**ADDENDUM No. 6
To the
Plans and Specifications
For

A New Facility for the
Fairhope Yacht Club**

**101 Volanta Avenue
Fairhope, Alabama**

May 9, 2007

NOTE: Owner furnished fixtures are similar to attached sheet.

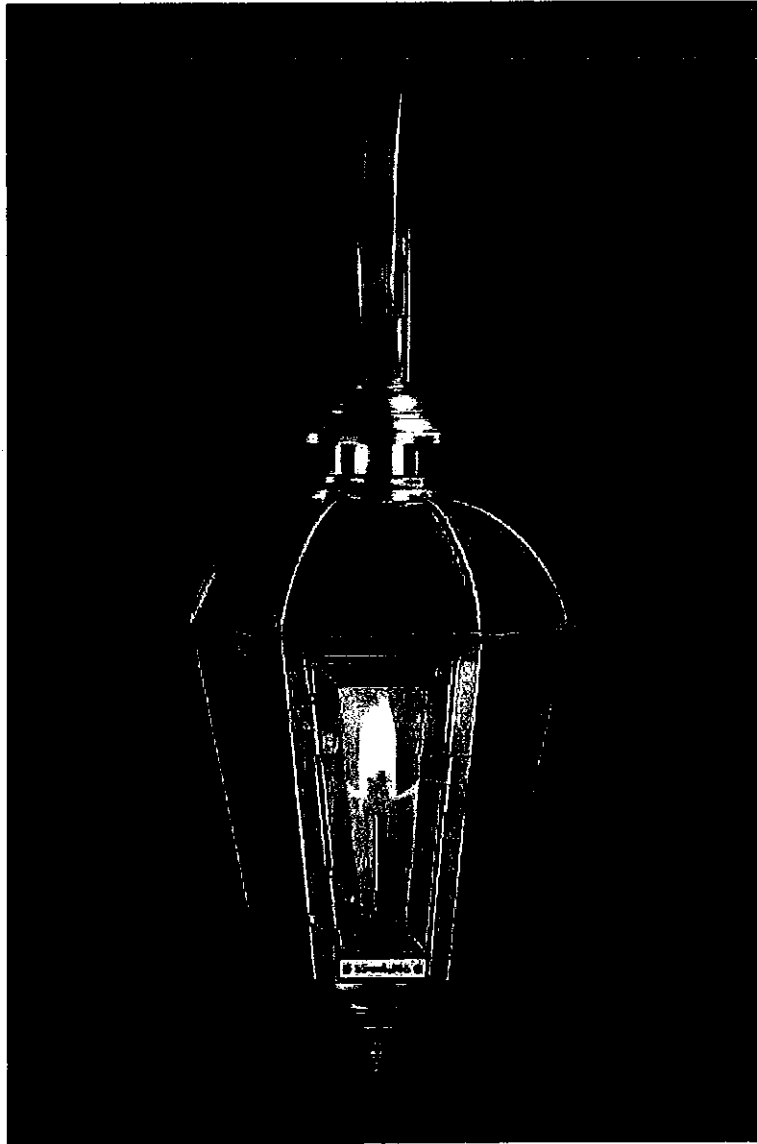
1. Ground Level-
 - a) Delete LL fixtures
 - b) Add 16 owner furnished fixtures (lamps included) – Wall mounted on concrete columns. - Conduit & boxes to be cast in place
 - c) Change circuit G-3 in panel to 30A
2. Main Level-
 - a) Add 12 owner furnished fixtures (lamps included) – Wall mounted. Coordinate mounting height with Architect / Owner/ Engineer.
 - b) Connect these fixtures to Circuit G-5.
 - c) Time clock control as shown.
